**Advisory Action
Before the Filing of an Appeal Brief**

10/725,732

FREEZE PROTECTION FOR HEAT PUMP SYSTEM
Applicant: Sienel; Serial No. 10/725,732
REPLACEMENT DRAWINGS

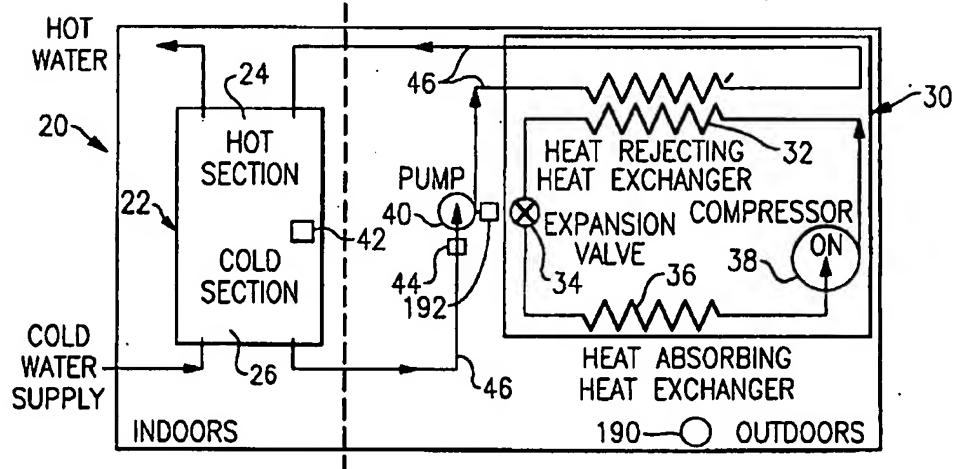
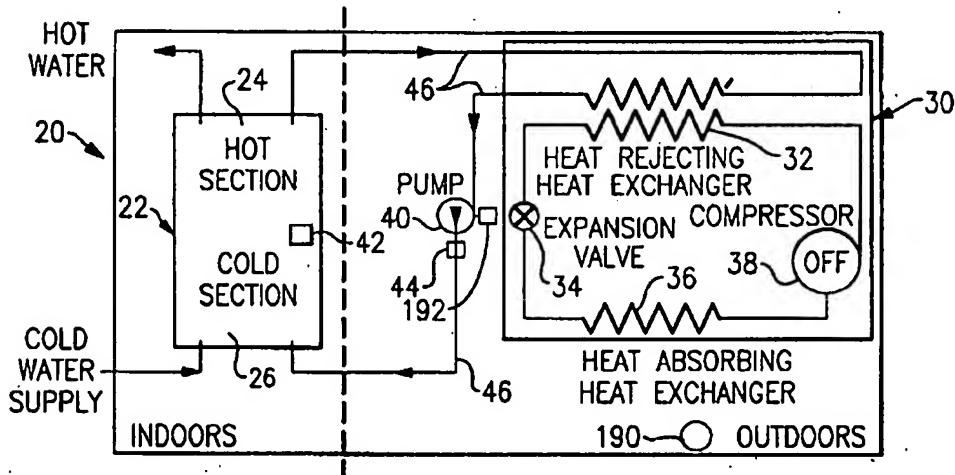
Continuation of 3. NOTE: A controller is not fully supported by the originally filed disclosure and thus constitutes new matter.

Continuation of 11. does NOT place the application in condition for allowance because: While the use of a controller may have been an obvious variant based on the originally filed disclosure, it is not inherent and hence all added references thereto constitute new matter without full support in the application as originally filed. It is not proper to add new matter to the claims, specification or drawings via amendment.

not
approved
due to new
matter JRC 11/21/07
